Australian Turf Club and Sydney's Light Rail project: Urban Impact Summary document- 18.12.2013

Sydney's Lightrail: Impacts Summary Sheet

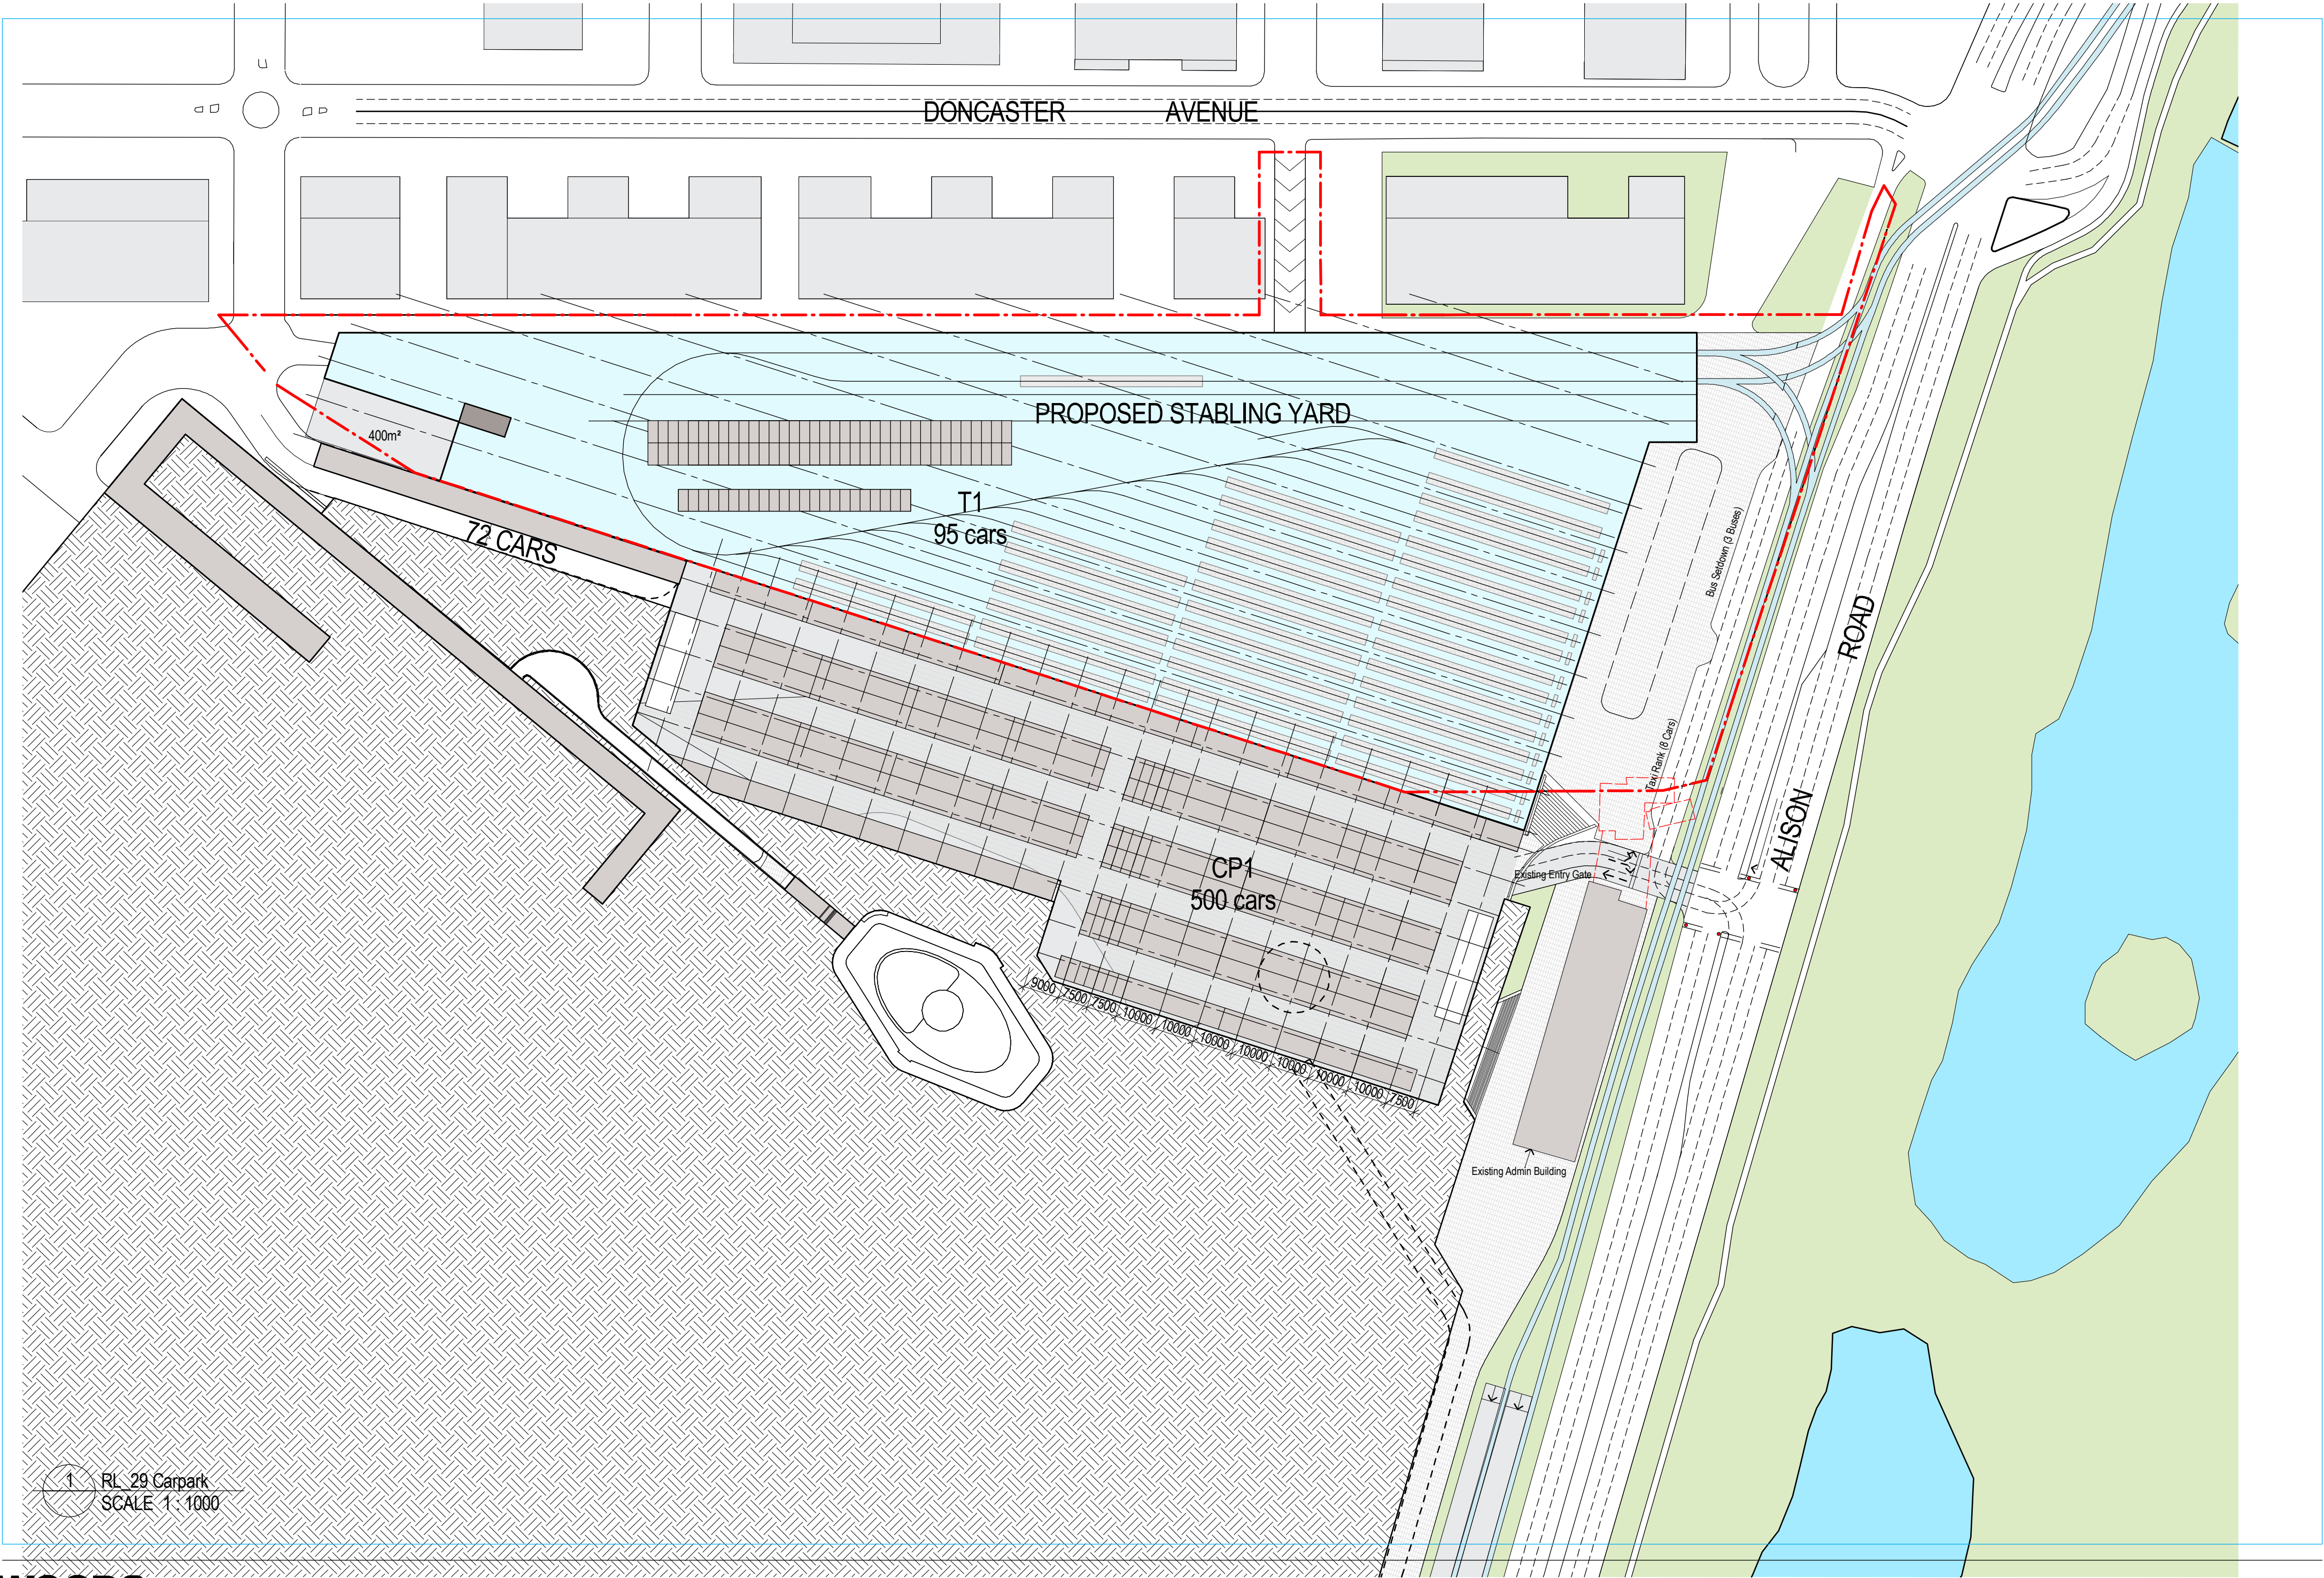
Proximity of track alignment to existing administration building severely reduces amenity inside the building and concern about elements of the building will need to be removed (sun shades, air-conditioning)
EMF, Noise, Visual Amenity

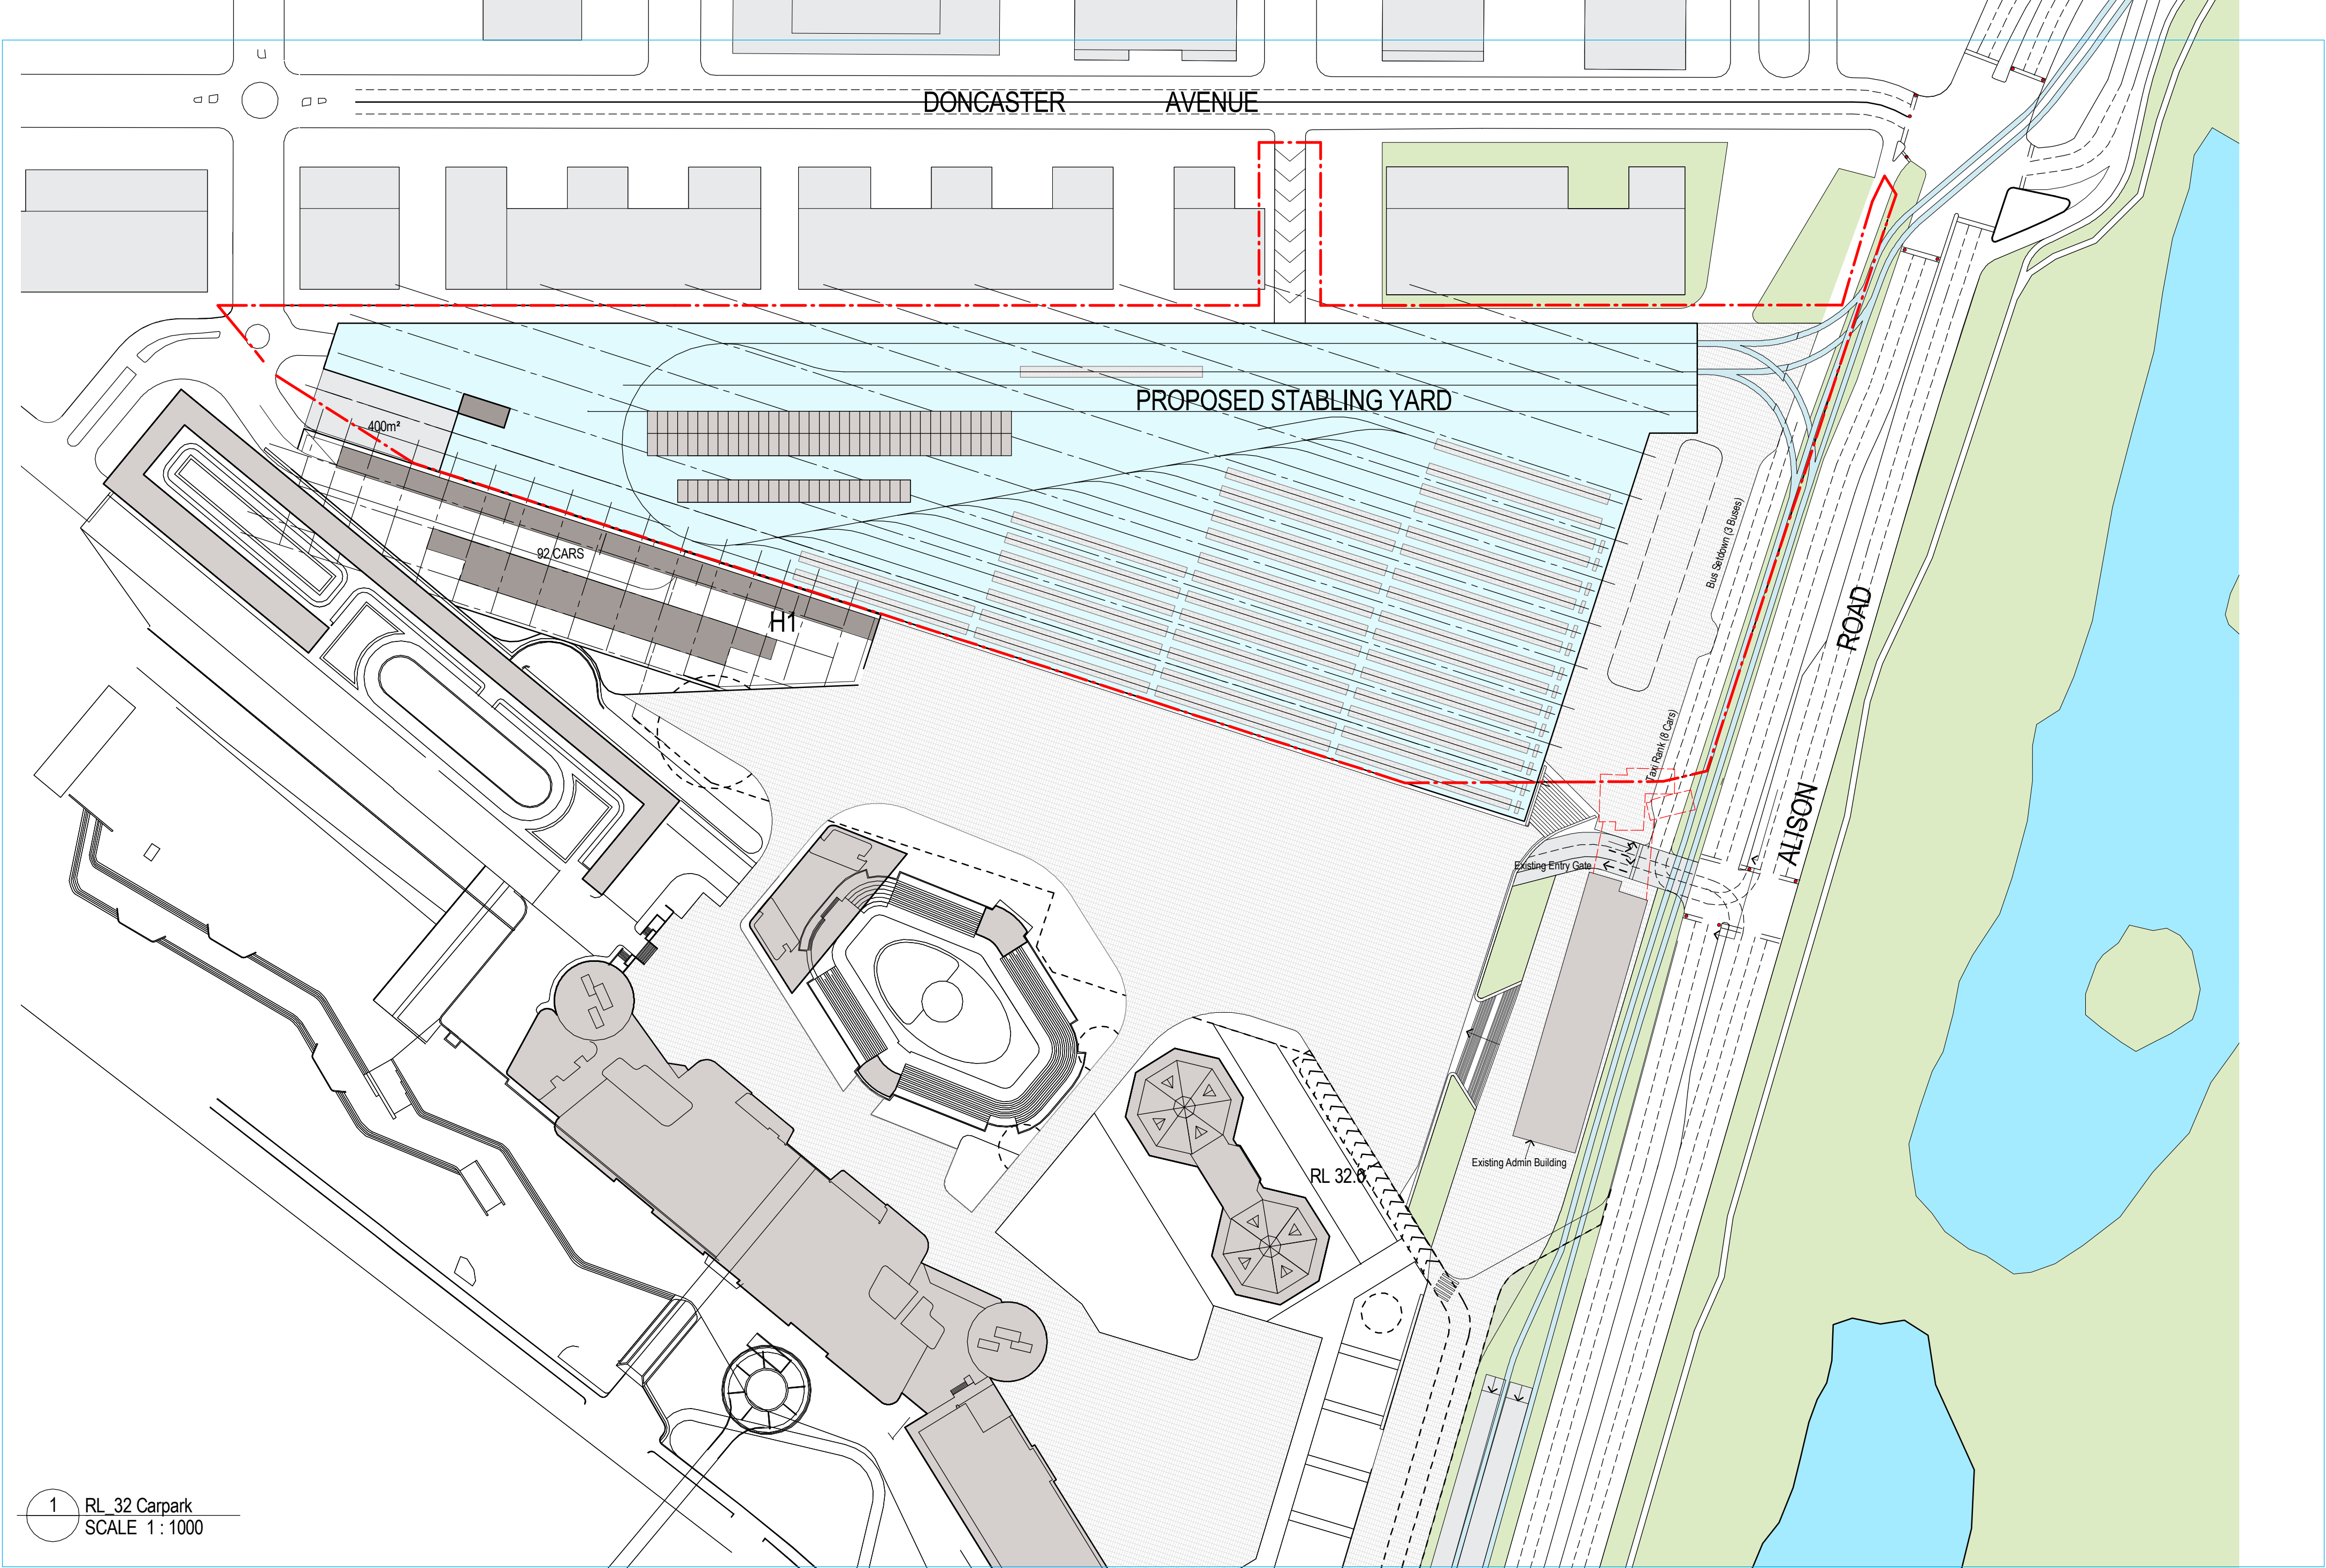
Pedestrians are required to cross the tracks to connect with the footpath on the south of the station to a footpath on the north located between the tracks and the road. It is potentially a safety risk and forces passers-by to carry out conflicting pedestrian movements with event patrons. Safety with pedestrians being pushed onto Alison and back onto rail lines

Island platform arrangement requires all passengers (east and west) to cross the lines. Side platforms would require only one direction to cross the lines.
